SYDNEY PLANNING PANEL

SPP Reference No	2017SWC106
DA No.	DA/758/2017
LGA	City of Parramatta
Proposed development	<p>Construction of a six storey Council facility including partial demolition of the Parramatta Town Hall and demolition of an existing external amenities block. The proposal seeks consent for construction and use of one basement level and one mezzanine basement level.</p> <p>The development application seeks approval for construction of the overall structure and exterior built form only. The use, signage and internal fitout would be subject to a separate development application/s.</p>
Address	5 & 7 Parramatta Square (1A Civic Place, Lot 2 DP 1192394, PARRAMATTA)
Applicant /Owner	City of Parramatta Council
Lodged	1 September 2017 Amended plans lodged 14 November 2017 and 16 January 2018
Integrated Development	The proposal was originally considered to be integrated development under the section 90 of the <i>National Parks and Wildlife Act</i> however an AHIP has previously been issued for the site. Accordingly the proposal is no longer considered to be integrated development.

List of all relevant s79C(1)(a) matters	<ul style="list-style-type: none"> • Environmental Plan

Figure 11: Leigh Place setbacks (Source: extract of DA-1601)

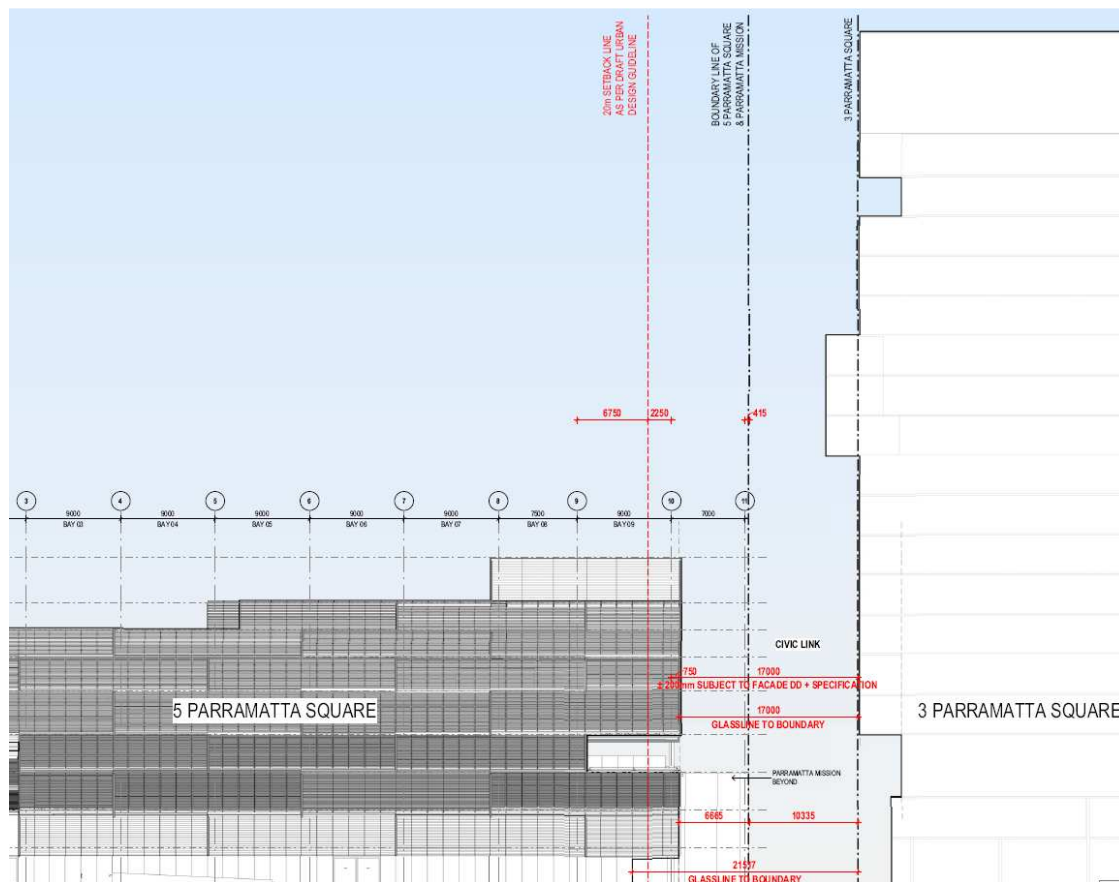
Given the approved alignment of 3PS the proposed 5PS building alignment adjacent to Leigh Place would therefore provide for Leigh Place to have a width of greater than 21m at the ground level (to a height of approximately 4.2m) but reducing to a minimum of 17m at the upper levels of the building where both the proposed 5PS and approved 3PS step out over their respective ground floors. The majority of the building is at the 17m line with increased setbacks at the ground and Level 3 only therefore it is considered that the width of Leigh Place will 'read' as 17m rather than greater. Further it is noted that the plans indicate that the setback could be increased or reduced by plus or minus 200mm subject to façade design development and specification therefore the ultimate width could be between 16.8 and 17.2m.

This is inconsistent with the Civic Link Framework Plan adopted by Council. Further it is noted that the assessment report for 3PS identified that at the time of writing it was understood that the setback to the proposed Council building at 5PS would be greater than 20m at the ground level and all levels of the building. It is therefore considered that this factored in to the Sydney Panel Panels decision to allow for a lesser setback on the 3PS building.

Notwithstanding the above, the Design Jury has provided advice which specifically notes that it is supportive of the eastern setback of minimum of 17m glassline to 3PS boundary and 21.517m ground floor to 3PS boundary (refer above). The Jury has indicated that “it considers that the building setbacks are generally consistent with the intent of the Civic Link Framework Plan, Parramatta Square DCP and the setbacks presented to the planning panel at the 3PS determination meeting”.

Having regard to the advice provided by the Design Jury, it is considered that the proposed alignment of 5PS at ground level and at the upper levels is appropriate in terms of pedestrian accessibility and urban design notwithstanding the minor inconsistency proposed with the Civic Link Framework Plan building alignment subject to a requirement that the separation between the main building wall of 3PS and 5PS is not less than 17m as recommended by the Design Jury. A condition to this effect should be applied to any development consent. It is considered that the overhanging of the space in part at the upper levels of the building will not adversely affect the functioning of the space nor the primary view corridor which extends north south.

Figure 12: Northern Laneway Overhang – worst case scenario 2.905m setback (Bay 04) (Source: extract of DA-1621)

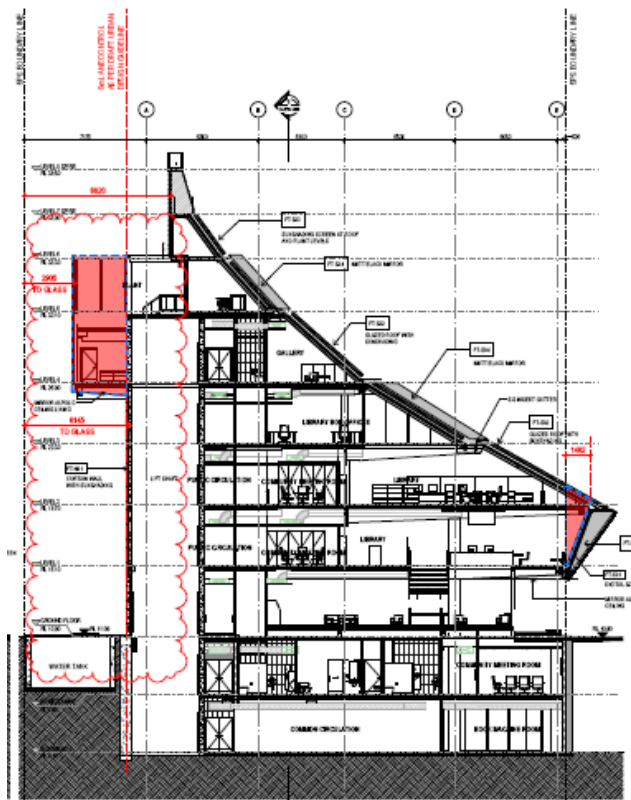
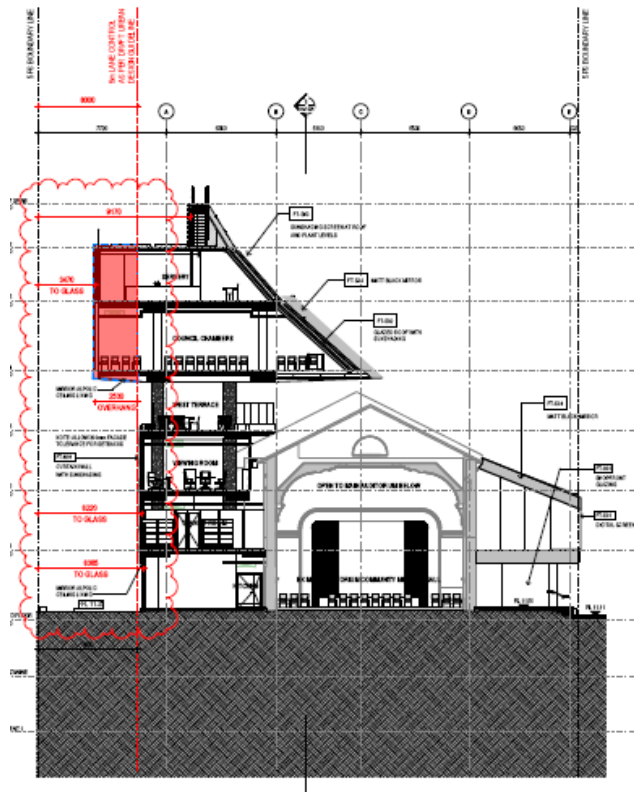
laneway by 3.25m with the resultant setback being between 2.9 – 3.44m (refer Figures 12 and 13 below). This element extends for 35% of the length of the elevation or 12% of the total northern elevation (refer Figure 14). The 6m laneway width is a requirement of clause 4.3.3.1 Building Form of Parramatta DCP 2011.

Council's urban designers have provided advice that the proposed laneway overhang is not acceptable and that the full 6m width of the laneway should be open to the sky. However it is considered that given:

it is concluded that the proposed overhang is acceptable.

Figure 16: Parramatta Square Digital Screen overhang – best case scenario width of 1.462mm at Bay 03 (Source: extract of DA-1621)

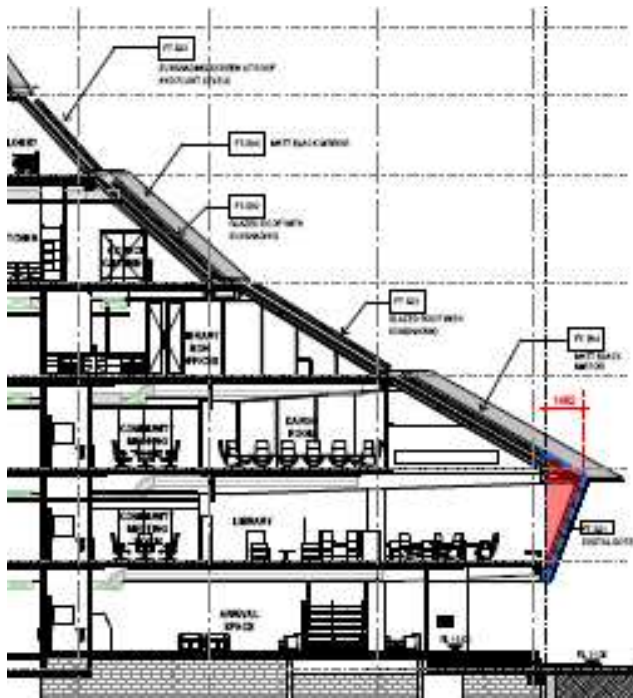
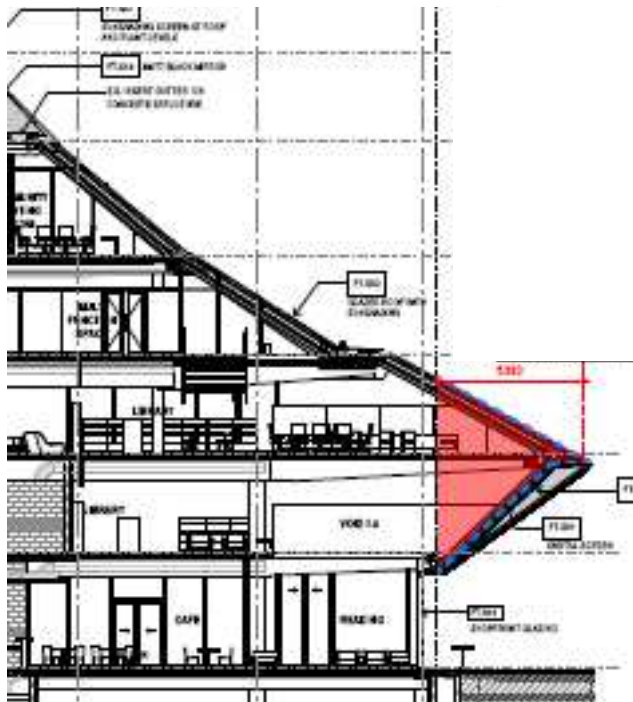
Further the proposed digital screen component of the design overhangs Parramatta Square along the building's southern façade for a variable width of between 1.462m at the western end to a maximum of 5.363m at the eastern end of the building at a height of approximately 7.7m. This element is a key component of the design of the building as highlighted by the Design Jury and will be a minor protrusion into the airspace over the Square. Accordingly it is considered acceptable given its significant contribution to the design quality of the building.
